## **ARLINGTON COUNTY, VIRGINIA**

Permit Holder	
Contractor	
Type of Work	Commercial Alteration
Brief Description of Work	INTERIOR ALTERATION- TENANT EXPANSION
Code Cycle	2012

RE: 1001 19<sup>th</sup> Street – Insight Global Permit Comment Response GHT project # 18808728 Permit # B1701636 Project ID # CTBO-3890

1 11TH FLR POWER/SIGNAL PLAN

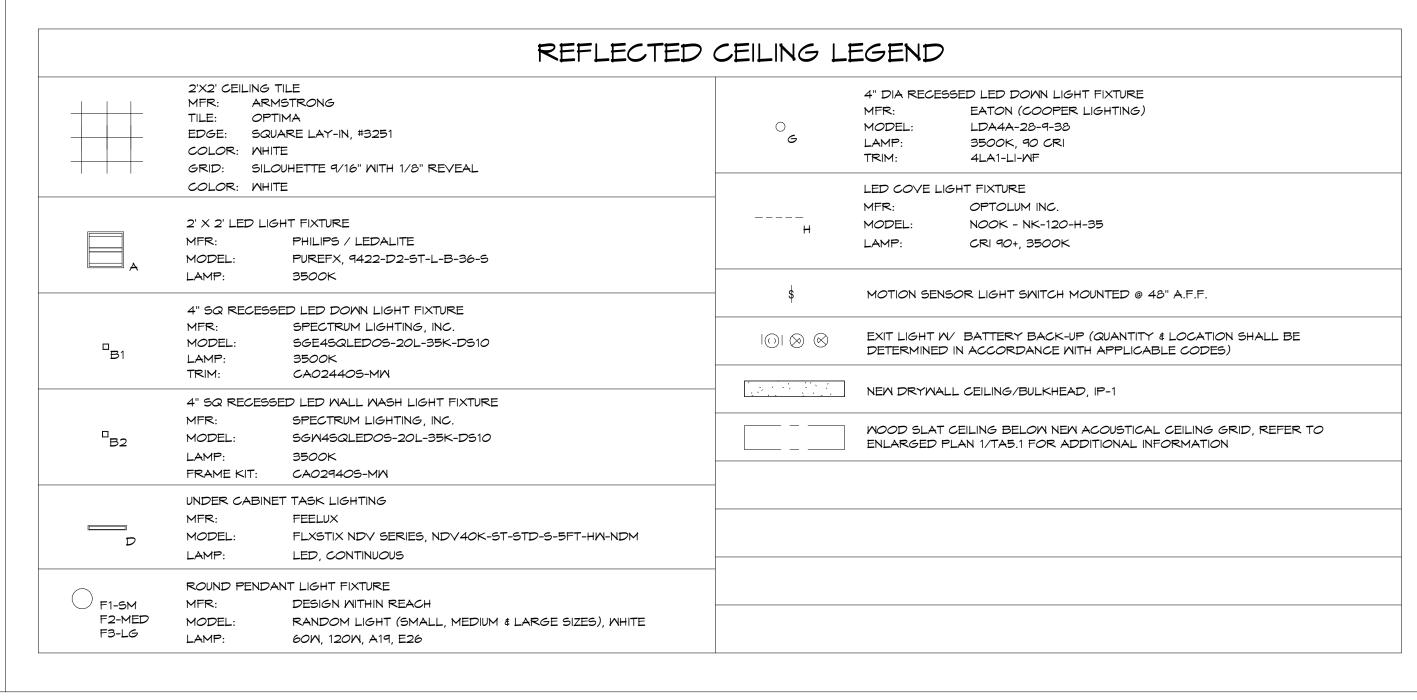
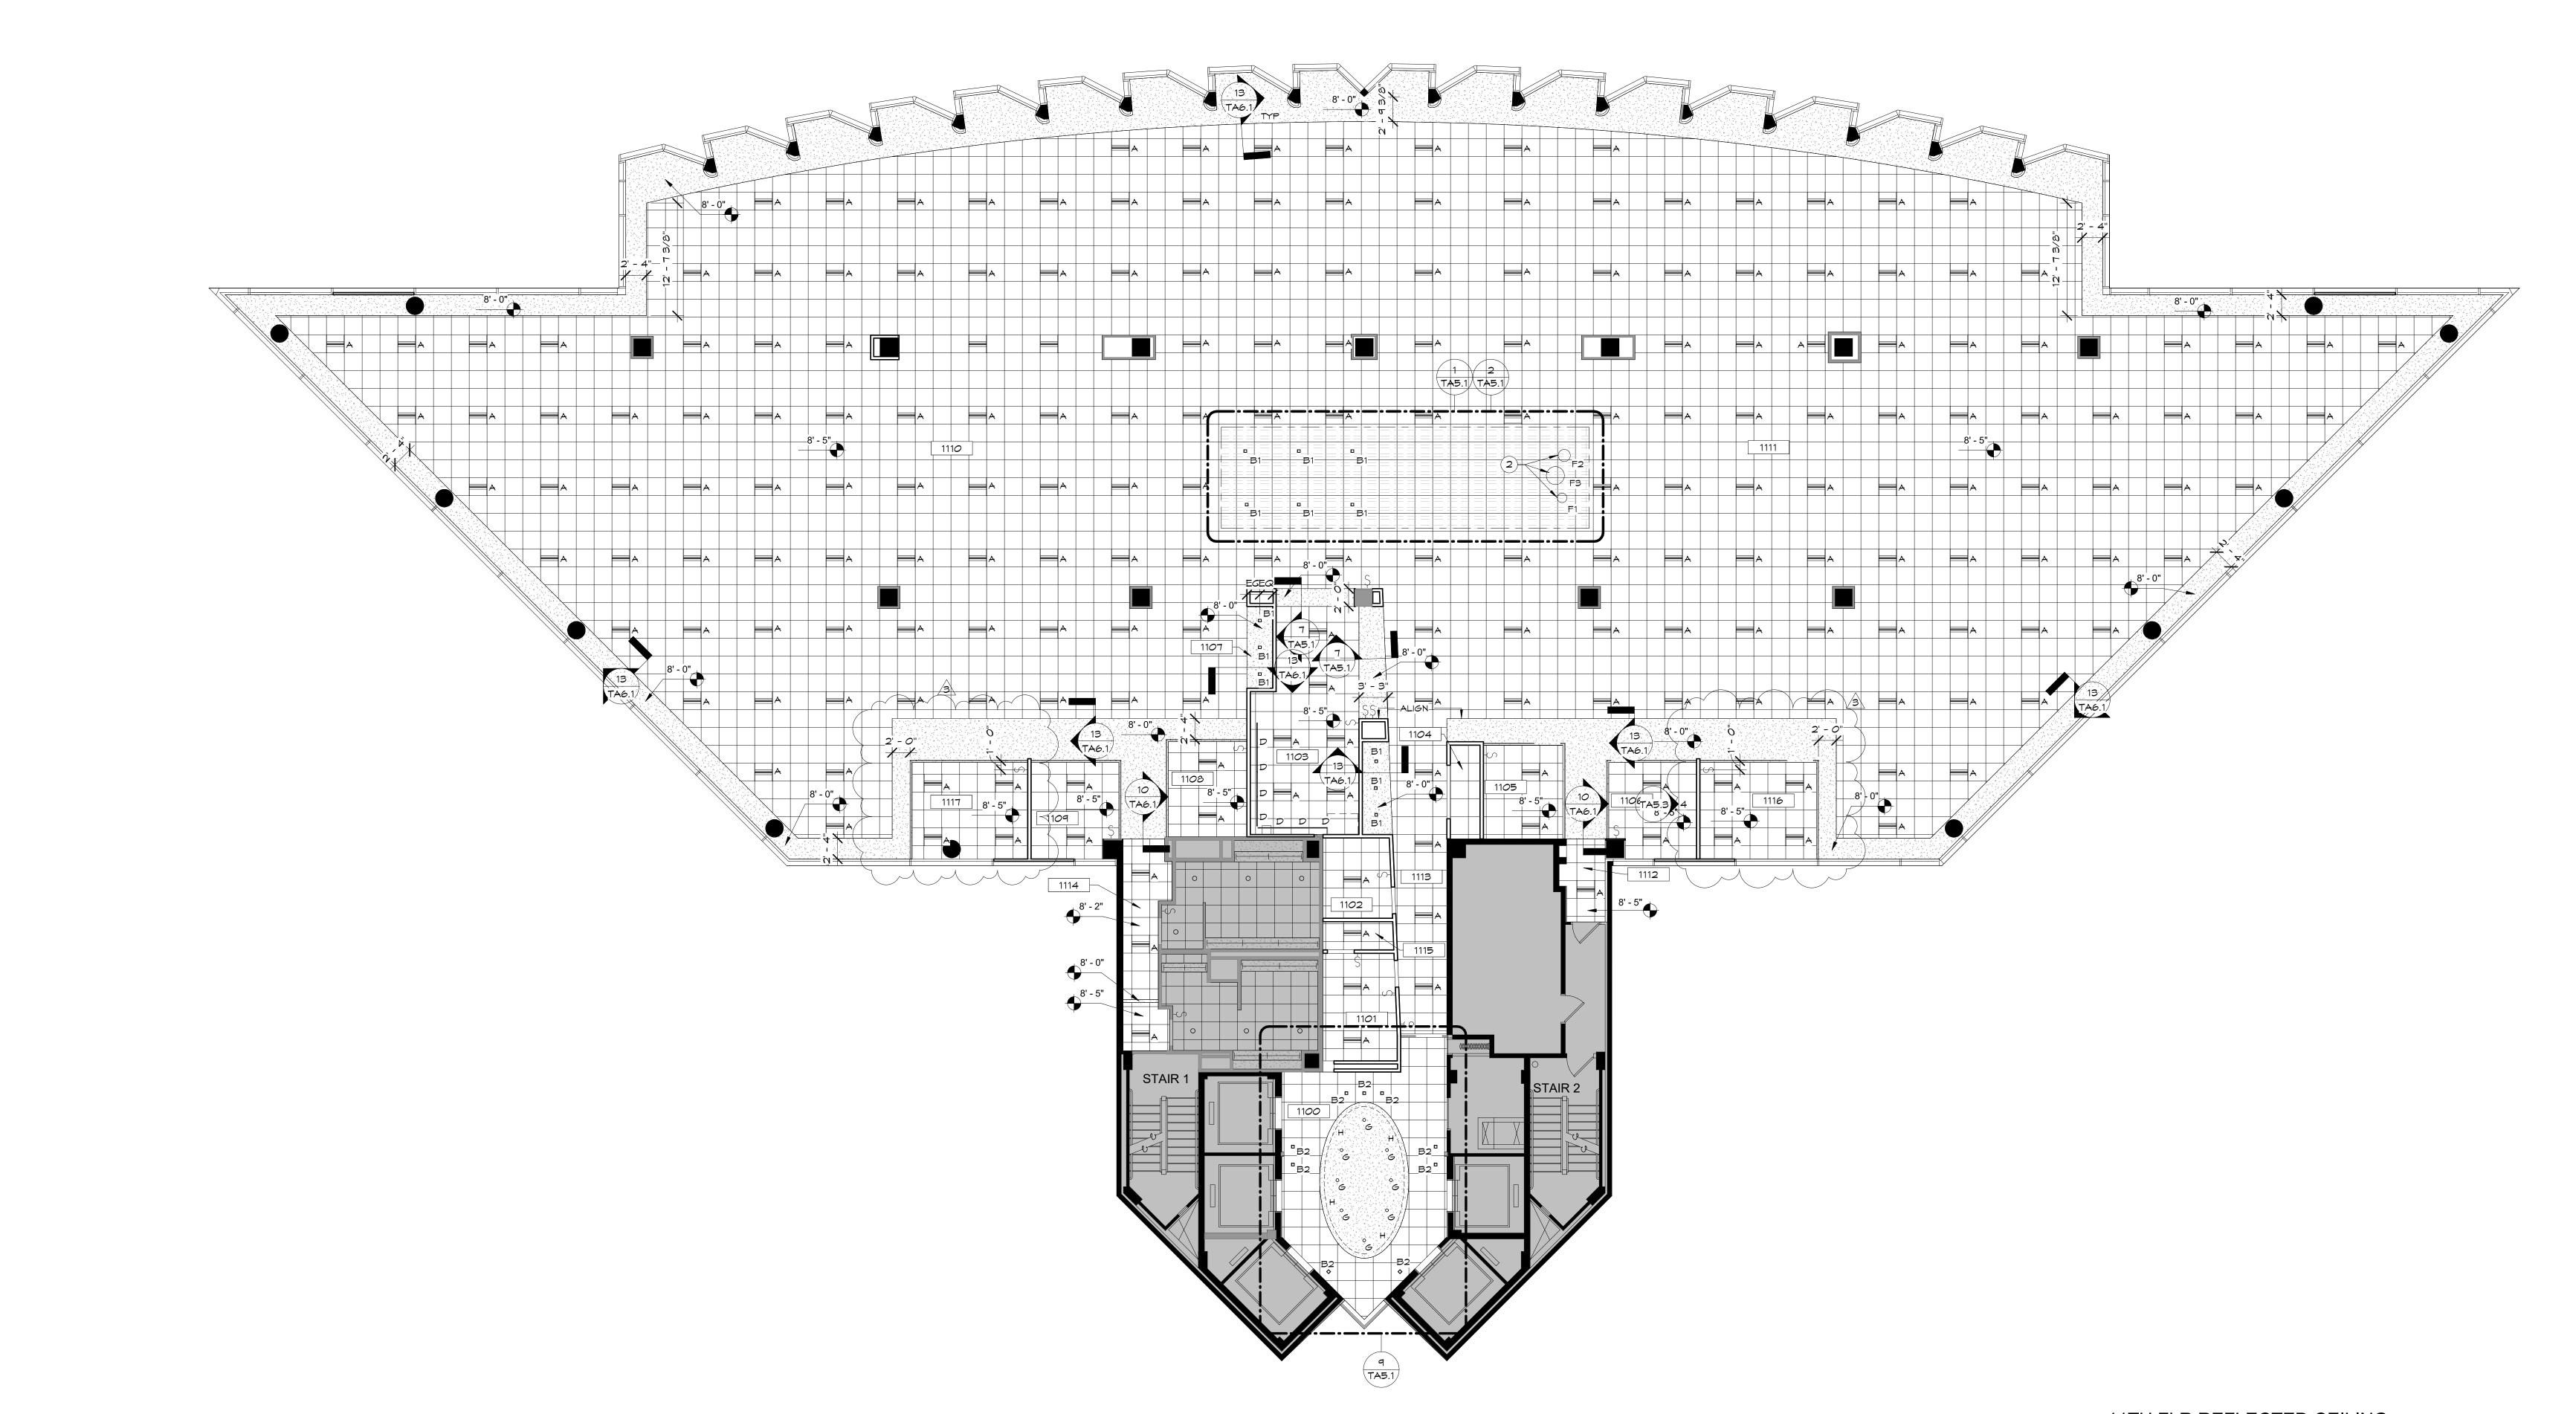
5. "A3-3-11 11<sup>th</sup> Floor Power Signal Plan – 18 July 2017: The sink in Pantry [1018] is not accessible as shown. See sheet A5-3, Detail 5. 2009 ANSI A117.1 606.2; 305.3; 306 – Provide

a forward approach. The space underneath the sink shall provide knee and toe plearanges G T O forward approach requires the removal of the cupboard doors under the sink – As an alternate, a parallel approach may be provided, with the prescribed clear space centered on the provided of the provided of the provided of the counter."

**Response:** TA5.3, Detail #5: the ADA knee clearance has been shown for the pantry sinks for the 10th and 11<sup>th</sup> floors. When the doors are fully open, a wheelchaired person will be able to use a forward approach to reach the sink.

GLAZING ELEVATIONS & SECTIONS

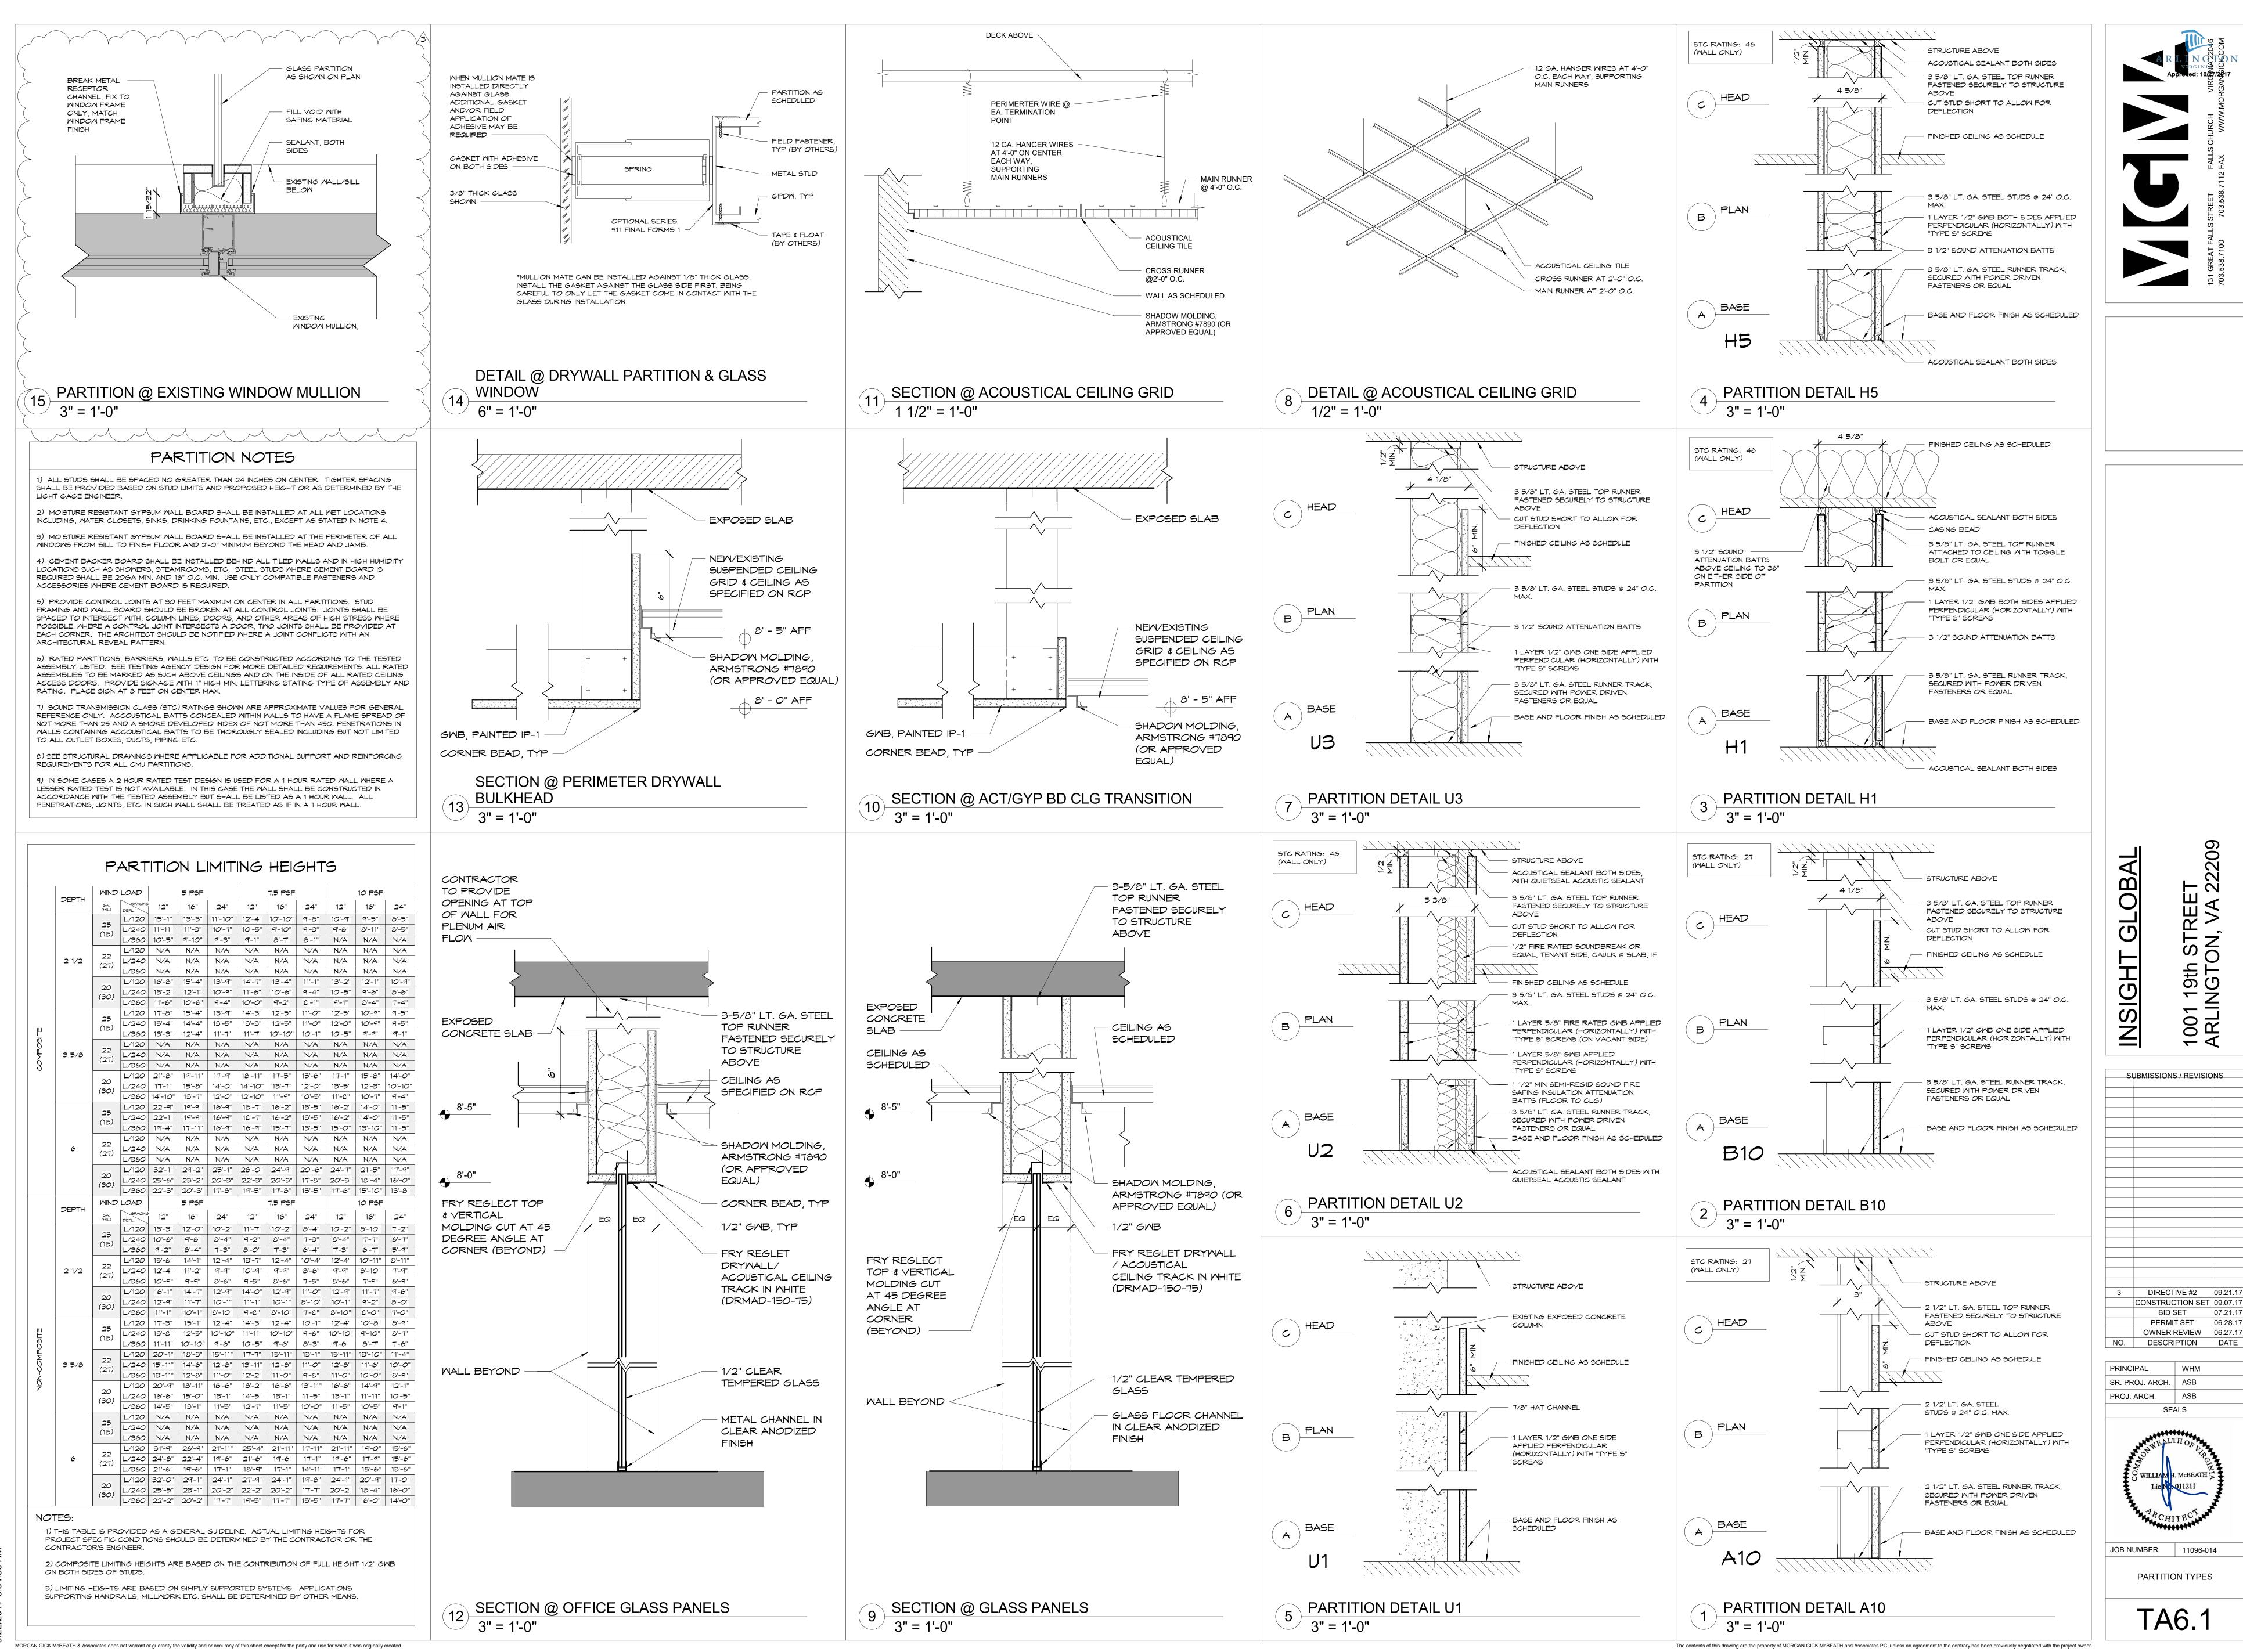
2. "A5-4 Glazing Elevations 9 October 2017 No elevation is noted for Offices #1108, #1109, #1117. Are these office walls expected to be similar to #1105, #1106, #1116? Verify.."

**Response:** Yes, Offices #1105, #1106 and #1116 are the mirror image of Offices #1108, #1109 and #1117. There is an elevation marker above Offices #1105, #1106 and #1116 that refer to an elevation #9 on sheet A5-4, which was included in the last submission. There is also an elevation marker above Offices #1108, #1109 and #1117 that also refer to elevation #9 on sheet A5-4 and is marked as OPP (Opposite).
